## PLANNING AND ZONING BOARD STAFF REPORT

### 398 NE 6<sup>th</sup> Avenue Development

| Meeting                                                    | File No.         | Application Type              |
|------------------------------------------------------------|------------------|-------------------------------|
| February 23, 2026                                          | 2025-082-SPF-LV3 | Level 4 Site Plan with waiver |

Provide a recommendation to the City Commission on a Level 4 Site Plan application for a four-story, 20,399 square-foot mixed-use building at 398 NE 6<sup>th</sup> Avenue including Architectural Elevations; a Landscape Plan, with an associated waiver to the minimum 20-foot required front setback depth above the third story, relief to the tower element above the third story, and a determination of adequacy for reduction of required off-street loading.

REAR ELEVATIONS

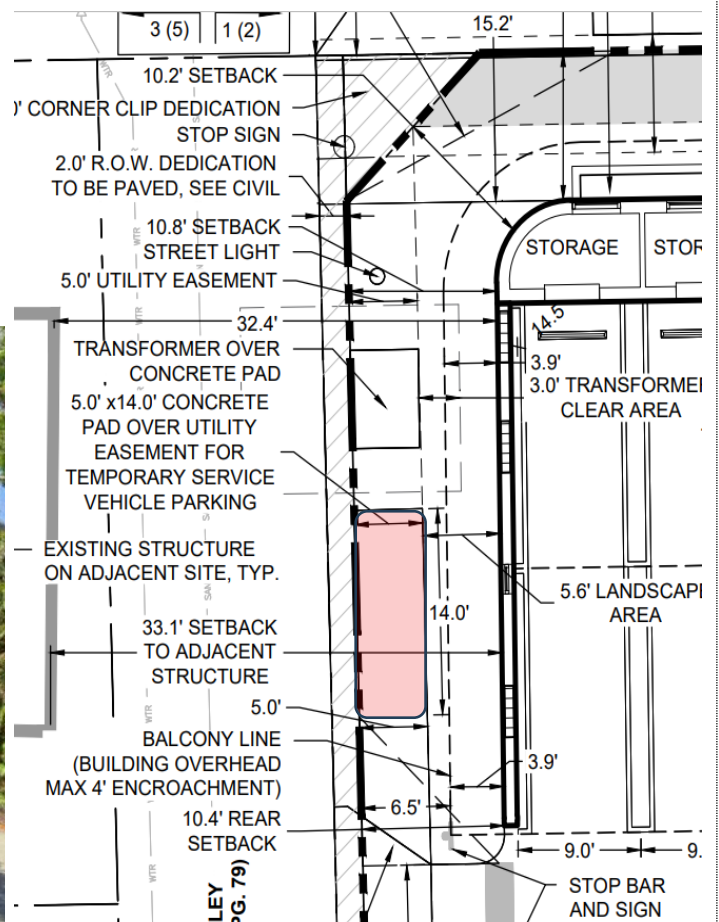
The project places parking and service functions at the rear of the site, consistent with adopted planning and design principles. However, due to the smaller urban infill environment, the provision of a full code-compliant loading berth would significantly impact the site circulation, parking layout, and building design. In this context, strict compliance with loading dimensions may not be feasible without undermining other urban design and functional objectives.

While this development proposal does not include any on-site dedicated loading zone, in-lieu of a full-sized loading berth, the applicant is proposing a 5-foot by 14-foot concrete pad located adjacent to the alley, within the site, to accommodate delivery vehicle pull-off and short duration loading activities. While this does not meet the dimensional standards of the LDR, it represents a deliberate attempt to address loading needs in a constrained urban setting. As such, it can be expected that during periods of move-in/move-out and delivery of large furniture and appliances, vehicles will at least partially obstruct the alley for significant periods of time. This may negatively impact the open flow of the alley network and negatively affect surrounding properties. The alley currently functions as a shared service corridor for multiple properties. Surrounding developments, including the property at 393 NE 5<sup>th</sup> Avenue and adjacent parcels to the south, already utilize the alley for parking, circulation and service access. The proposed project follows this established pattern by orienting parking, refuse, and delivery activity toward the alley rather than primary streets.

Given the modest scale of the development, the frequency of loading is expected to be limited and primarily associated with residential move-ins, package deliveries, and small-scale retail operations.

As such, the proposed arrangement is not anticipated to create a significant or unsafe impact on the alley or surrounding street network. Instead, it represents a practical response to site constraints while maintaining the intent of the loading and circulation standards by keeping service away from major street networks. In evaluating the proposed loading arrangement, the Board should consider whether the alternative approach adequately fulfills the intent of Section 4.6.10 of the Land Development Regulations, which is to ensure that loading and service activities occur in a manner that protects public safety and maintains efficient circulation. The applicant's justification is attached.

NORTHWEST CORNER

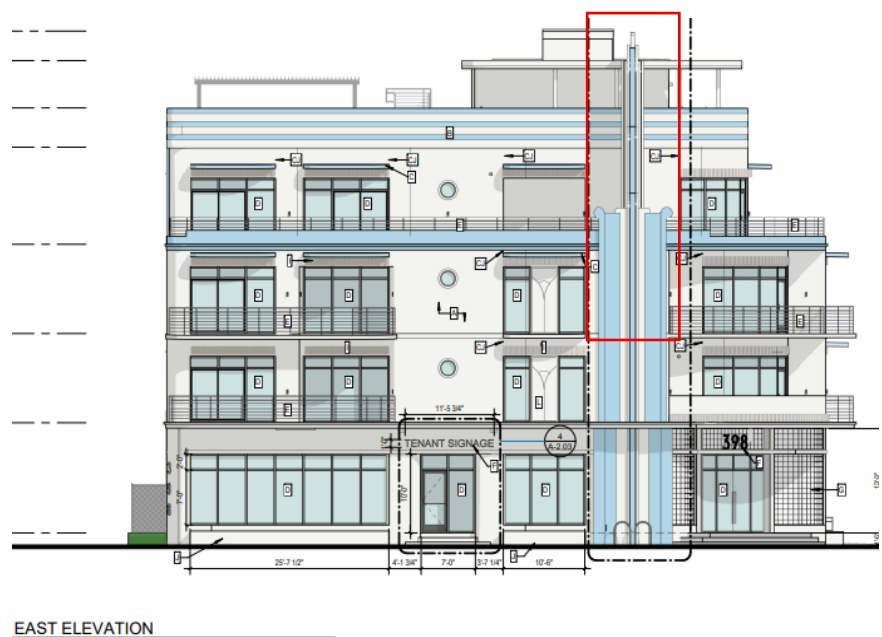
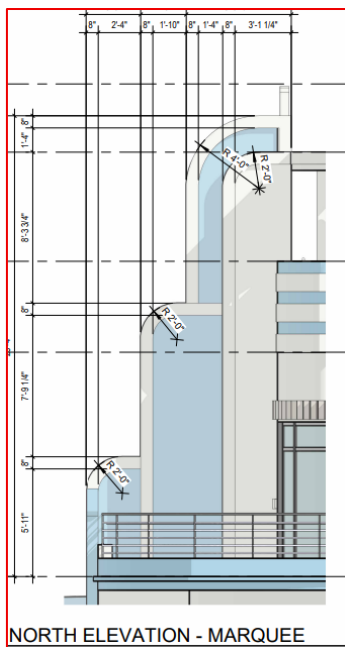
The proposed design incorporates a tower element extending above the third story, providing vertical articulation and reinforcing the building's corner presence. LDR Section 4.4.13(D)(2)(a)1.b. provides that, with approval from the board, building entries, lobbies, and vertical circulation areas located above the second story may not be required to increase the setback to 20 feet when configured as tower elements determined to be consistent with the CBD Architectural Design Guidelines.

The tower element appears integrated into the overall Art Deco architectural composition through consistent material application, horizontal banding transitions, vertical emphasis, and proportional relationship to the primary building mass. Vertical tower or marquee-style elements are characteristic of Art Deco architecture, where vertical features are often used to contrast strong horizontal banding, emphasize building entries, and create visual identity at prominent corners. The proposed tower element reflects these architectural principles and is incorporated into the overall façade composition rather than appearing as an isolated vertical projection.

From an architectural and urban design perspective, this element contributes to façade articulation, corner identity, and skyline variation typical of mixed-use buildings within the Central Core Sub-district. The Board may determine that the tower element is appropriate, consistent with the Architectural Design Guidelines, and may approve the configuration as presented.

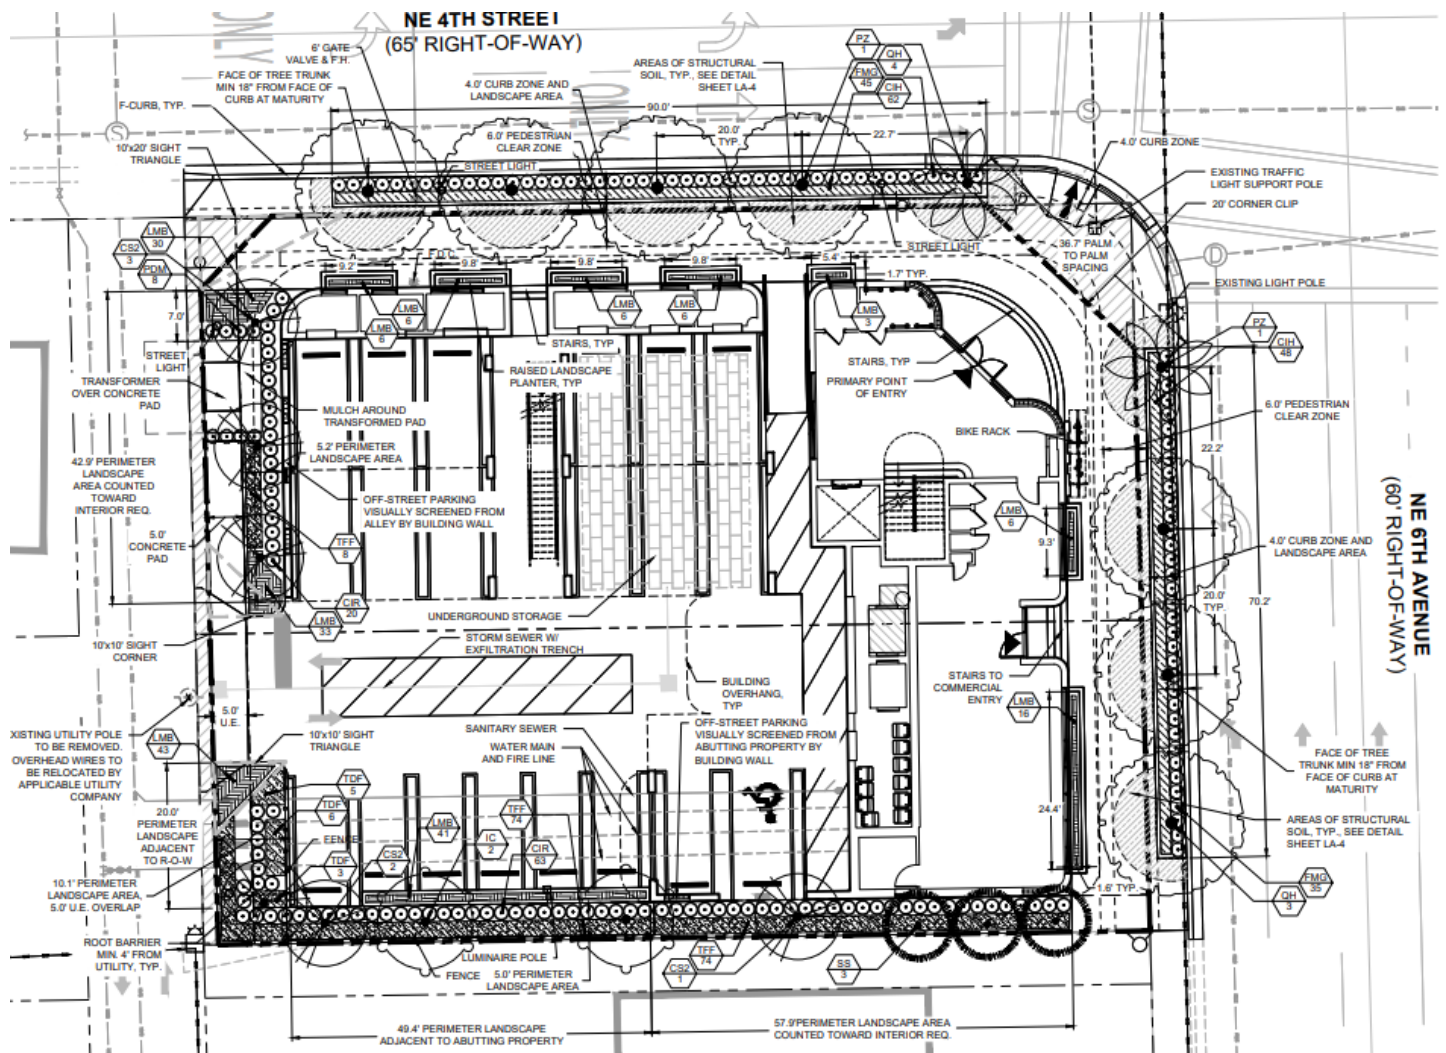
A technical review of this site plan has been performed, and a determination has been made that the project complies with all applicable landscape regulations. Landscaping is interspersed throughout the site in a way that is appropriate for the urban setting, where some foundation landscaping is incorporated to soften the mass, while a wide sidewalk is simultaneously paired with street trees to establish a walkable corridor. The landscape plan provides mitigation in the form of three (3) 3-inch caliper Silver Buttonwood trees (9-inch total caliper) and one (1) tree-for-tree replacement, which satisfies the required mitigation for the tree removal. A full landscape plan is available as an attachment. Tree disposition and mitigation information is available on sheet LA-2.
